VILLAGE OF LOMBARD
INTER-DEPARTMENTAL REVIEW GROUP REPORT

PREPARED BY: Jennifer Backensto, AICP
Planner I

PC 05-12; 2810-2830 S. Highland Avenue (Highlands of Lombard): The petitioner is requesting that the Village take the following actions pursuant to the Highlands of Lombard Annexation Agreement and subsequent amendments thereto located within the Highlands of Lombard B3 Planned Development:

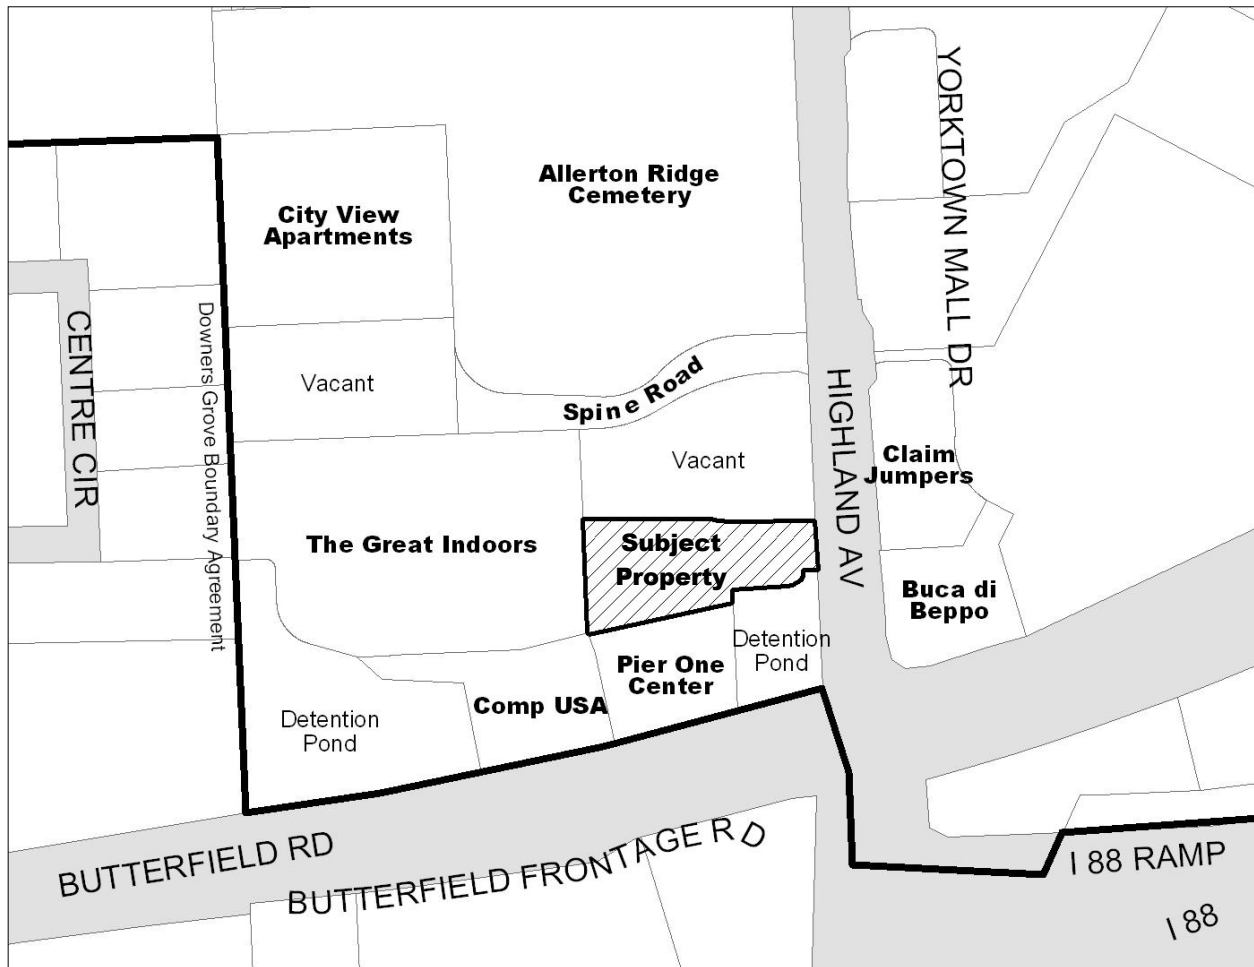
4. Construction must not disturb the electrical grounding system that surrounds the lift station. See attached diagram. Contractor will be responsible for testing grounding system at completion of project to ensure its integrity.
